Construction Observation

DISTRIBUTI	LLJ
PROJECT	Lincoln Park Zoo Pavilion	REPORT #	2		
LOCATIO	Chicago, Illinois	TRIP DATE	September 24, 2020		
PROJECT	_	ENGINEER/OB	Dave Eckmann		
CLIENT	Studio Gang Architects	TODAY'S DATE	11/5/2020		
CONTRA	Pepper Construction	PAGE	1 OF 11

Purpose: Site visit with Harry Soenksen of Studio Gang to observe the condition of the pavilion and provide recommendations on improving current conditions and future maintenance.

Figure 5. Wood Spalling at Grid C – West

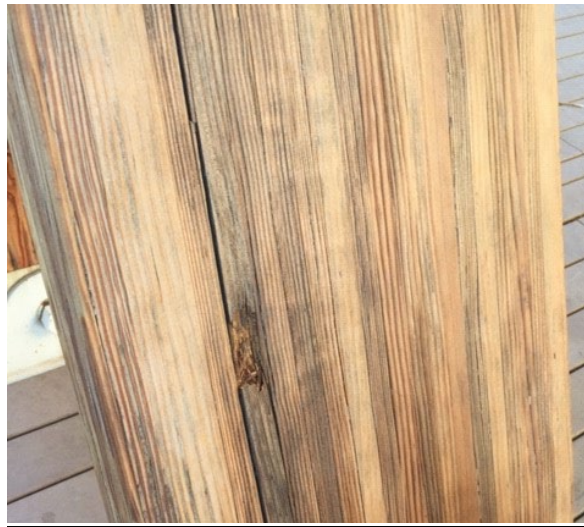
4. A similar timber-spalling condition can be found away from the connections, shown in **Figure 5**, which occurs near the base at Grid C-west.

Recommendation: Sand areas to remove dirt and debris. Follow Option 1 or 2 listed above for repairing. Re-apply Heritage oil as recommended by Heritage Natural Finishes.

Figure 7. Delamination Along West Side

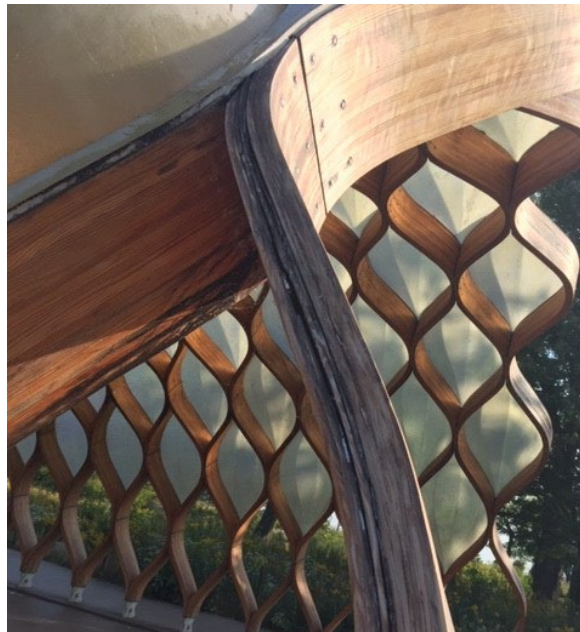
6. There are several areas, particularly along the west side, where some delamination has occurred along the narrow face of the timber member (see **Figure 7**).

Recommendation: Sand areas to remove dirt and debris. Two options for repair are listed below. Option 1 is recommended for aesthetics and performance over time. After repair, re-apply Heritage oil as recommended by Heritage Natural Finishes.

Option 1: Clamp laminations together with screws. Recommend contacting Rick Collins of Trillium Dell Timberworks – rick@trilliumdell.com - or a similar contractor. Added screws can be hidden with wood filler.

Option 2: Patch area with wood filler – recommend using Abatron WoodEpoxy or equivalent.

Option 3: Replacement - A long term solution would be replacement of the member. It is possible to remove and replace the member without compromising the structure. If this route is selected please contact SGA, MKA and Trillium Dell for further coordination.
